LEVEL 1 — OVERALL FLOOR PLAN (REV L)

CHANGES FROM REV K (all ASSUMED)

PROJECT Hazel Green Regional Athletic Complex Trojan Horse Arena · Hazel Green area, Madison County, Alabama (site TBD, D-006)	PHASE PHASE 2	SHEET TITLE OVERALL FLOOR PLAN LEVEL 1 · BLOCK PLAN	SCALE 1" = 40'-0"	DATE October 2026	REV L	DRAWN BY Drawn by KEYSTONE (AI) for Shane Brazelton	SHEET P2-A-101
--	-------------------------	---	---------------------------------------	---------------------------------------	-----------------	---	------------------------------

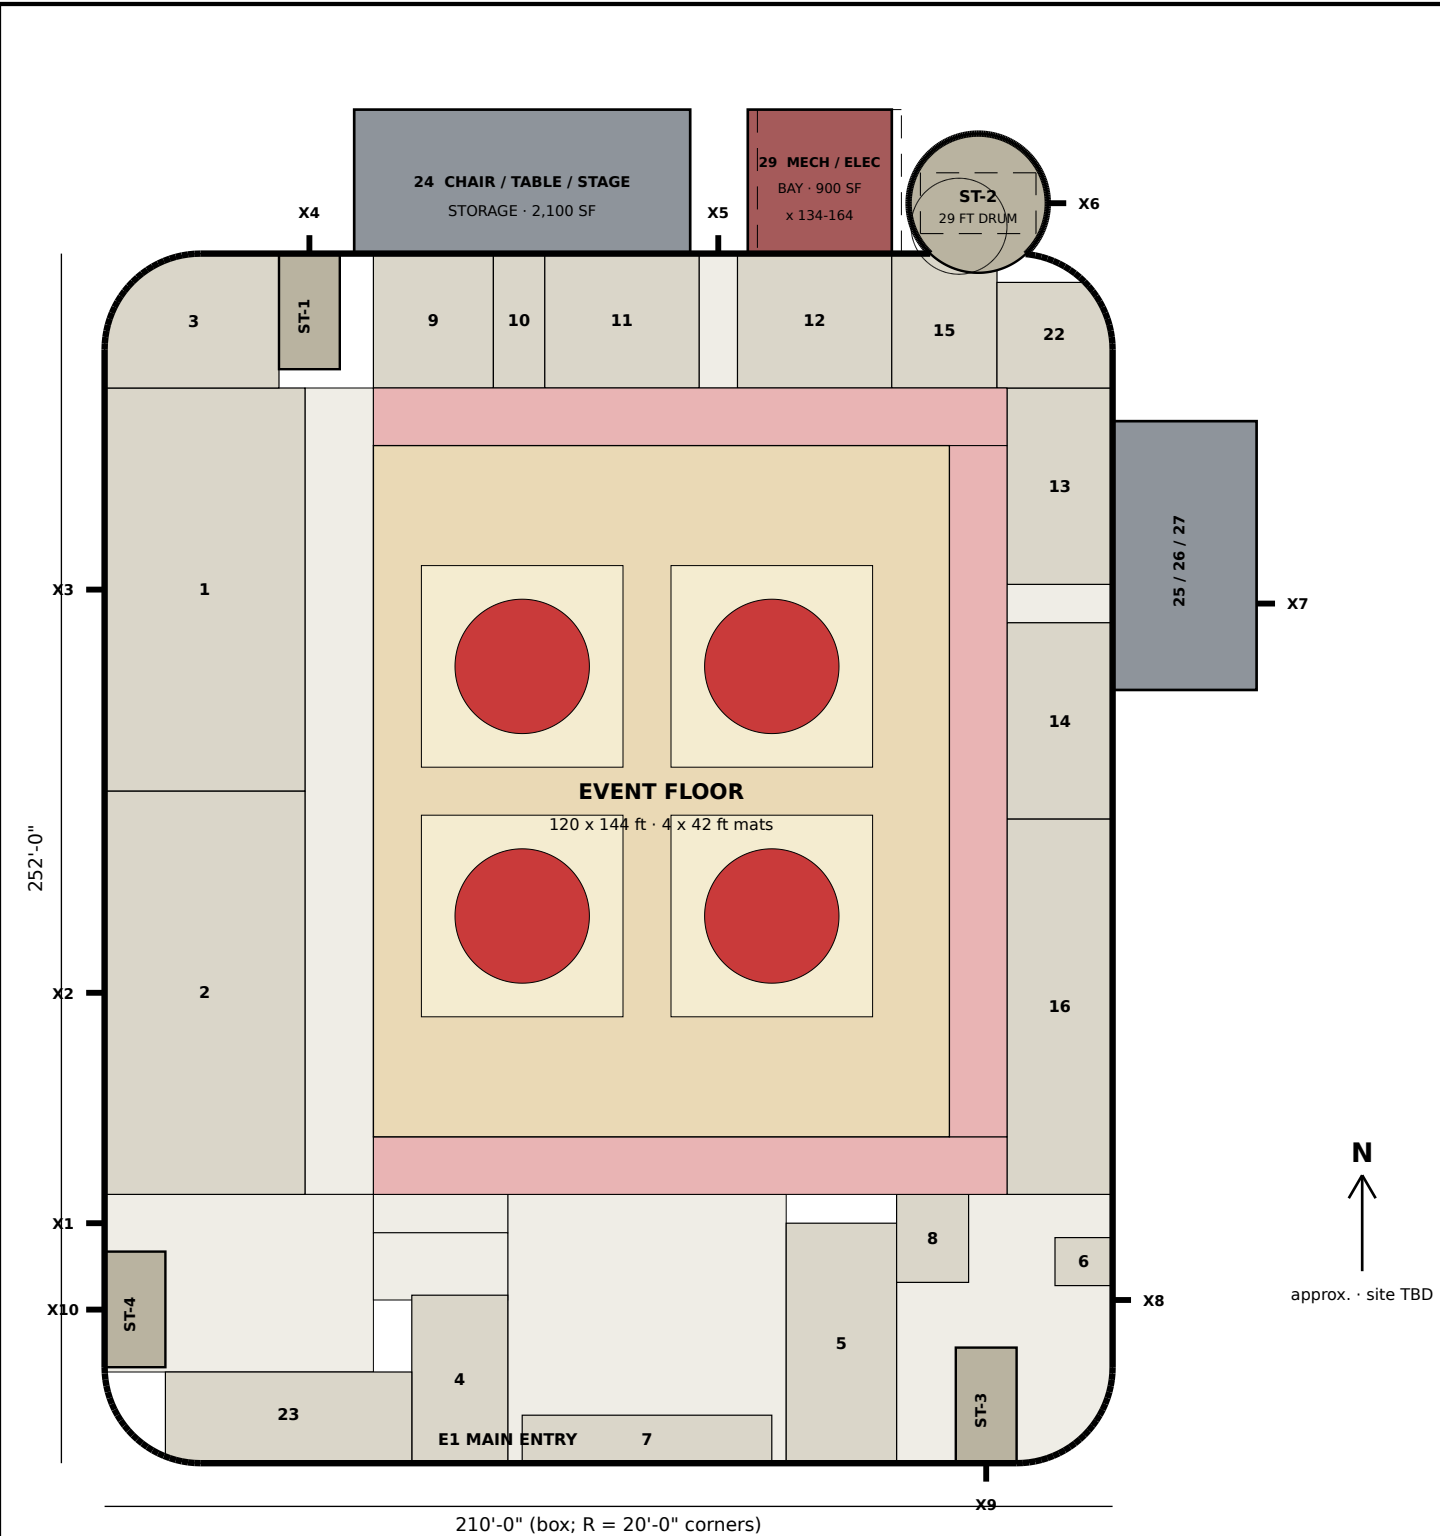
Rev K (approved, D-079) with the NE stair tower resized to a 29 ft drum (D-081); everything else as drawn on Rev K (P2-A-101_RevK.dxf). Rev K tower and bay shown dashed.

- ST-2: 20 ft tower at (178, 257.7) becomes a 29 ft drum centred (182, 262.5), west edge x 167.5; the outline still wraps it. +341 SF on this level (D-080 F1, D-081).
- Stair fit: 12.67 x 24.08 ft stair (dashed), diagonal 27.2 ft inside about 27.7 ft = 0.49 ft spare (about 3 in at each end corner). The Rev K tower had room for 15.5 ft of run.
- X6 on the drum east face (196.5, 262.5), to open ground NE.
- 29 MECH / ELEC BAY slides 2 ft west to x 134-164 (900 SF): 3.5 ft to the drum; EXIT (N) at X5 keeps a 12 ft lane between the annex and the bay (passage 1.85 ft from the annex, 2.15 ft from the bay).

Rev K column net of the 20 ft tower (P2-G-002 Rev E F3: the Rev K sheet did not deduct it from MECH (N)). The old Rev F-J ST-2 strip inside the box (x 185.9-210, y 246-252, about 71 SF) stays unassigned, as on Rev K.

- Drum wall: 0.49 ft spare assumes about 8 in walls; a thicker wall or a stair larger than 12.67 x 24.08 ft does not fit (architect).
- East side as approved on Rev K = plan Rev I (bump-out y 161-217, X7 on its face, no X11), not plan Rev J (D-072). Rebase in a later rev? (P2-G-003 Rev L).
- Structure of the curved shell and the 29 ft drum; tier depth 1'-6" or less (D-061). Exits: see P2-G-003 Rev L findings.
- SRM / Summertown Metals roles are not agreed; names are descriptive, no marks used (D-042).
